V1 PART A: RESIDENTIAL

1 Scope of Report

- [1] This Recommendation Report prepared by the Independent Hearing Panel (IHP) relates to submissions and further submissions that were received on the Residential chapters of Part A of the SDC's Intensification Planning Instrument (IPI) which is otherwise known as Variation 1 to the PDP.
- [2] The IHP members were:
- Lindsay Daysh
 - Raewyn Solomon
 - Rob van Voorthuysen (Chair)
- [3] The Section 42A Report¹ was:
- Section 42A Report, Part A of Intensification Planning Instrument – Variation 1 to the Proposed District Plan, Report on submissions and further submissions, Residential, Jocelyn Lewes, 27 March 2023
- [4] Our recommended amendments to the IPI provisions are set out in Appendix 1.

RESZ-SCHED1 – Measuring Setback
MRZ

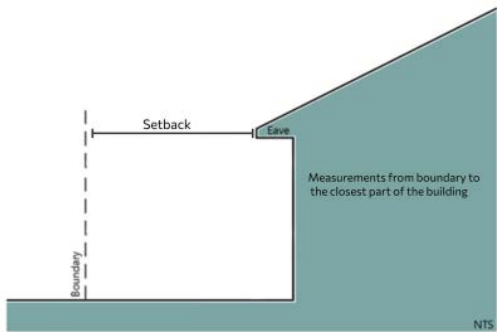
- [50] For the following submissions we adopt Ms Lewes' recommendations and reasons. In particular we agree that an illustration should be included in RESZ-SCHED1 to improve its clarity.

- [51] We recommend that the SDC:
- (a) Inserts an illustration into RESZ-SCHED1 to improve clarity.

...
Insert the following figure below the text⁵¹
